PREFERRED PROJECT REPORT AND REVISED STATEMENT OF COMMITMENTS

CONCEPT PLAN MP05 _0091

BAYSIDE BRUNSWICK RESIDENTIAL SUBDIVISION BRUNSWICK HEADS

DECEMBER 2012

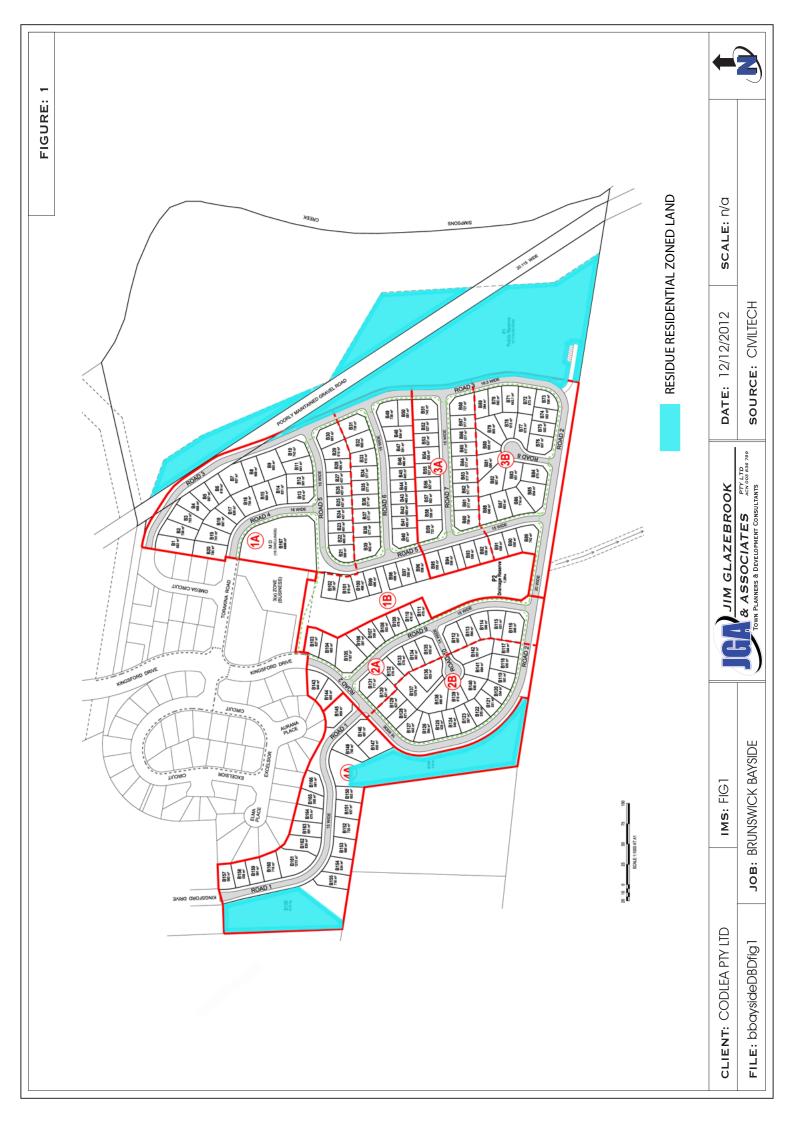
Some of the submissions suggest changes to the layout which would substantially reduce yield. There is a genuine concern that these changes would affect the project's overall viability, particularly given the reductions already made by the proponent and discussed in the concept plan report.

- Substantial areas (approximately 5.3 hectares) of residentially zoned land will remain undeveloped and conserved for ecological purposes either by way of dedication or 88B instrument restrictions. This is shown on Figure 1;
- The Brunswick Heads Settlement Strategy 2004 indicates that the undeveloped parts
 of Bayside Brunswick Estate have the capacity for approximately 270 lots. The
 proposal for 164 lots represents a 106 lot reduction in potential. The Strategy
 identifies that there is no other land available in Brunswick Heads for subdivision,
 other than by resubdivision of a few isolated large lots; and
